City of Richmond
Planning and Development Department

Report to Development Permit Panel

To: Development Permit Panel
From: Cecilia Achiam
Acting Director of Development
Date: October 15, 2007
File: DP 06-352760
Re: **Application by Jordan Kutev Architect for a Development Permit at
6860 Eckersley Road**

Tree Protection Fencing Detail

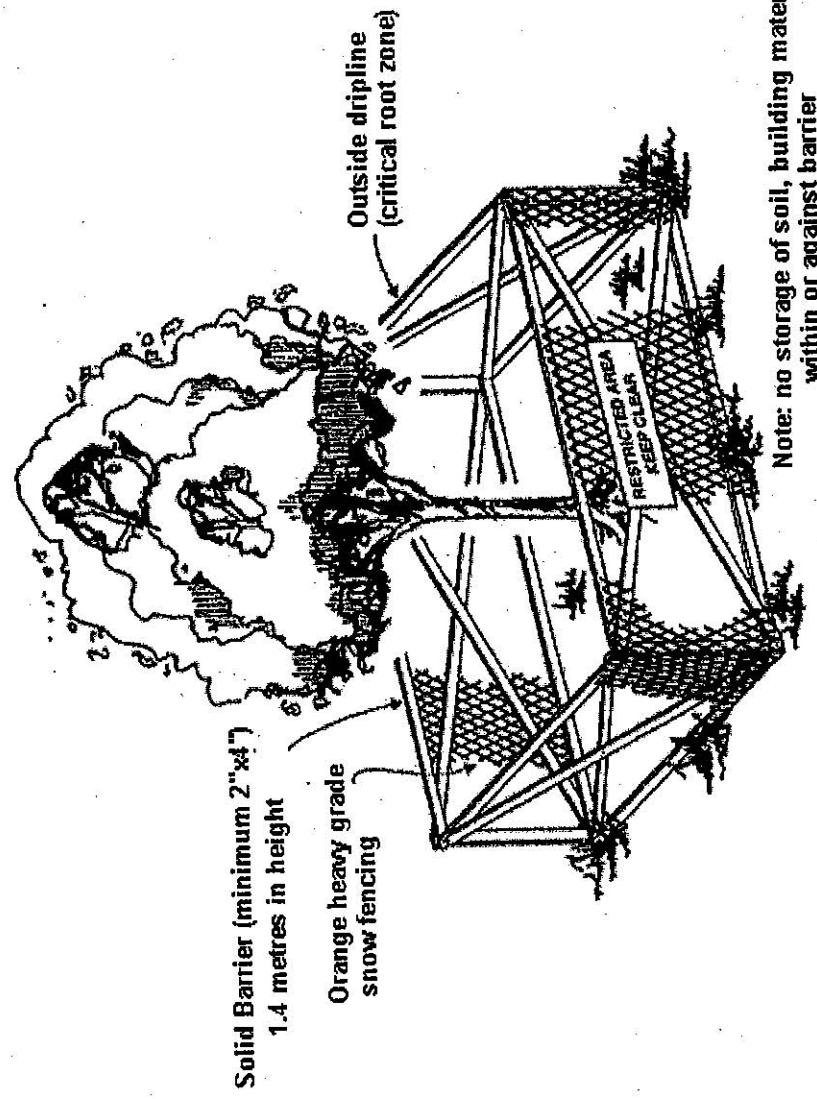
1. Before anything else happens on the site the tree protection fencing will need to be installed around all the protected trees as per my revised report dated November 10, 2006. I have provided a Tree Protection Detail in the Appendix. DONE

APPENDIX 3
REVISED TREE PROTECTION PLAN

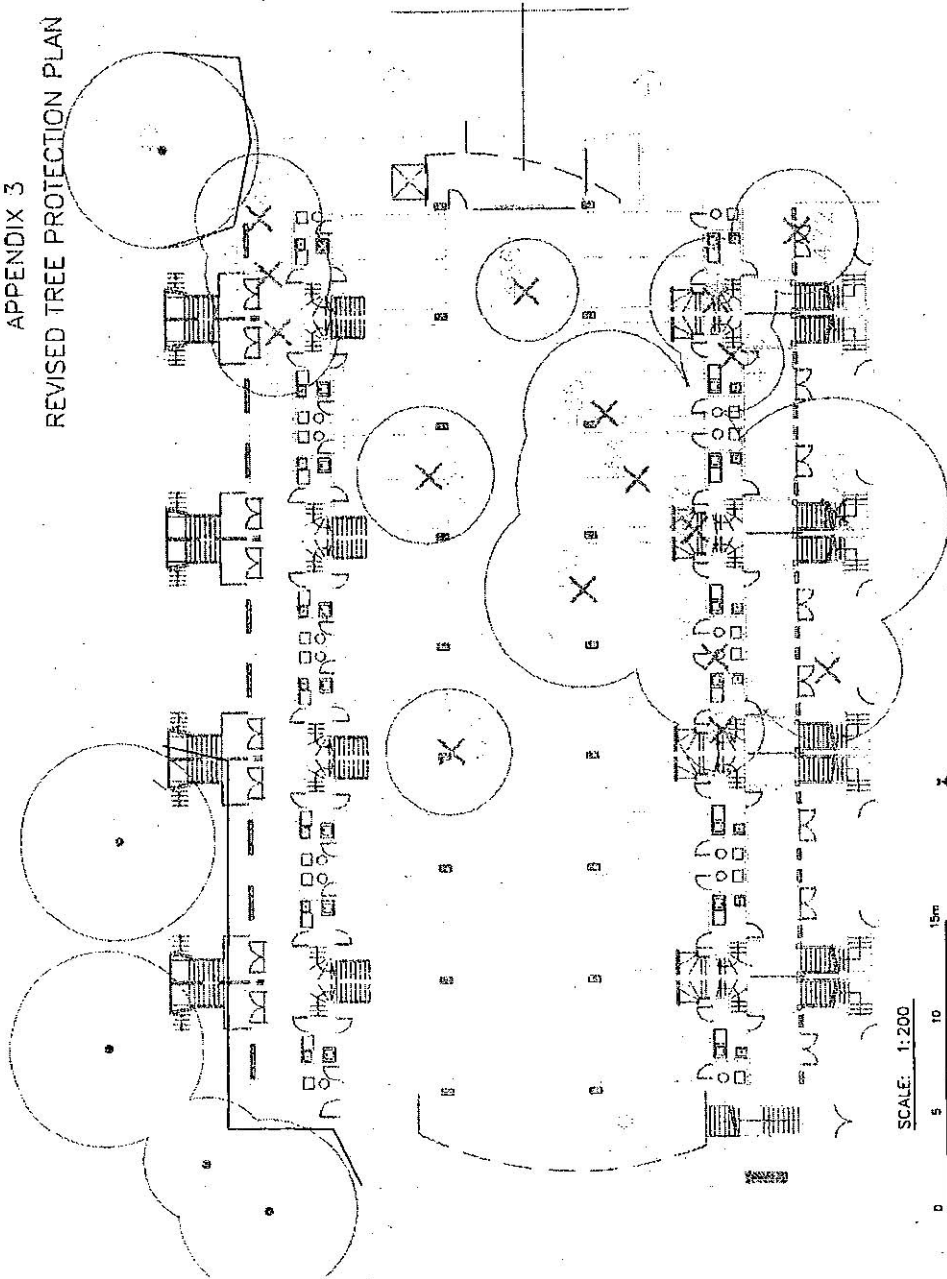
All retained trees on the property and neighbouring properties will be surrounded by Tree Protection Fencing as laid out in the **Revised Tree Protection Plan** drawing Appendix 3. All fencing must be constructed to a robust standard and clearly signed: "TREE PROTECTION AREA – KEEP OUT" See Appendix 2 for construction details.

BUILDING ELEVATIONS

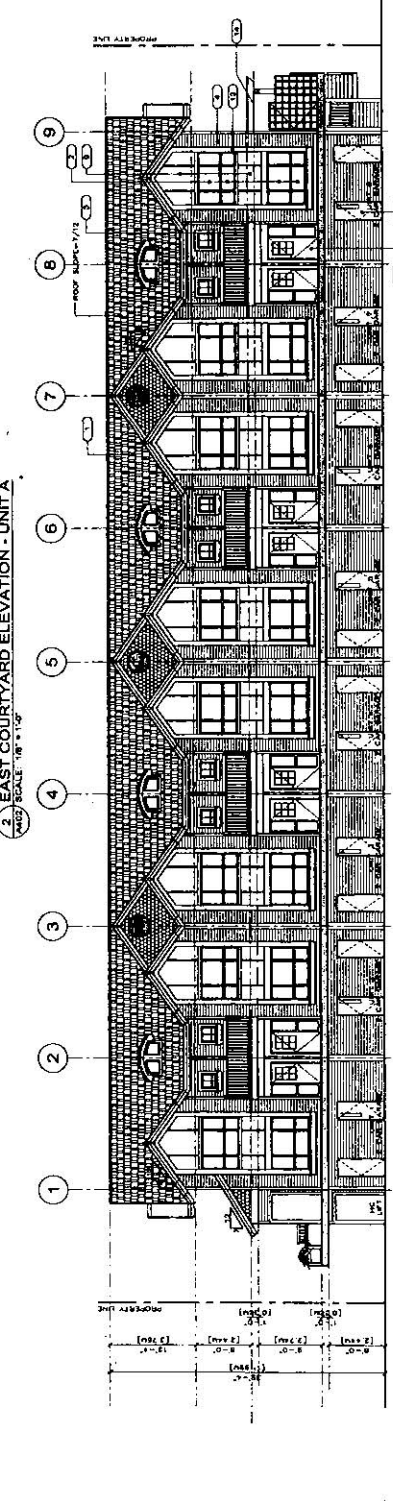
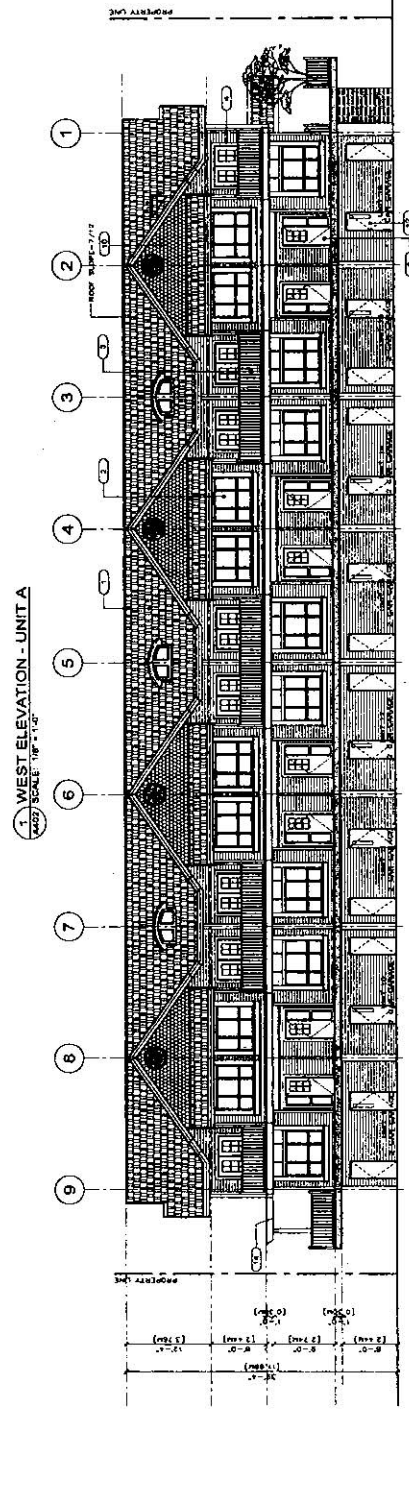
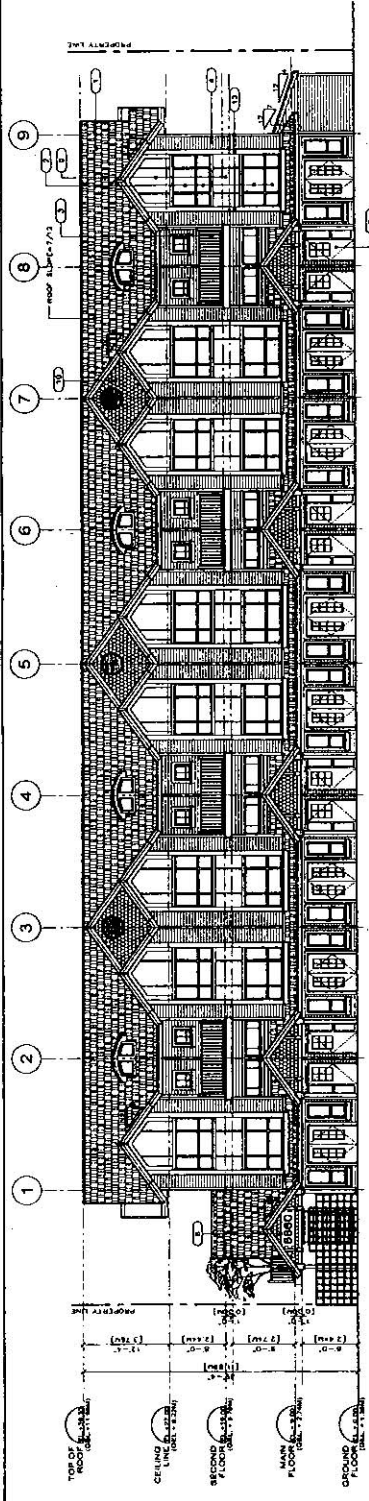
- Further design development of the Anderson Road façade to reflect its street fronting location to ensure the Anderson Road elevation becomes a feature of the development.

- focus on the ends of buildings, the Anderson Road elevation is a critical issue, create a courtyard rd space with lively outdoor rooms that are well used spaces and try to contain the ends with a trellis feature or other detail to provide further definition and give it an inviting and private feel;
- revise the unit plans at the two ends to make the project inviting from the Anderson road frontage.

The cantilevered outdoor space located above the parking access on the south elevation has been revised to function as linking architecture between the two (2) building elements. The orientation of the stairways has been flipped. The cantilevered element extends to become the upper tier of the stairway and the lower tier of stairs is repositioned adjacent to the building better defining itself as private space.
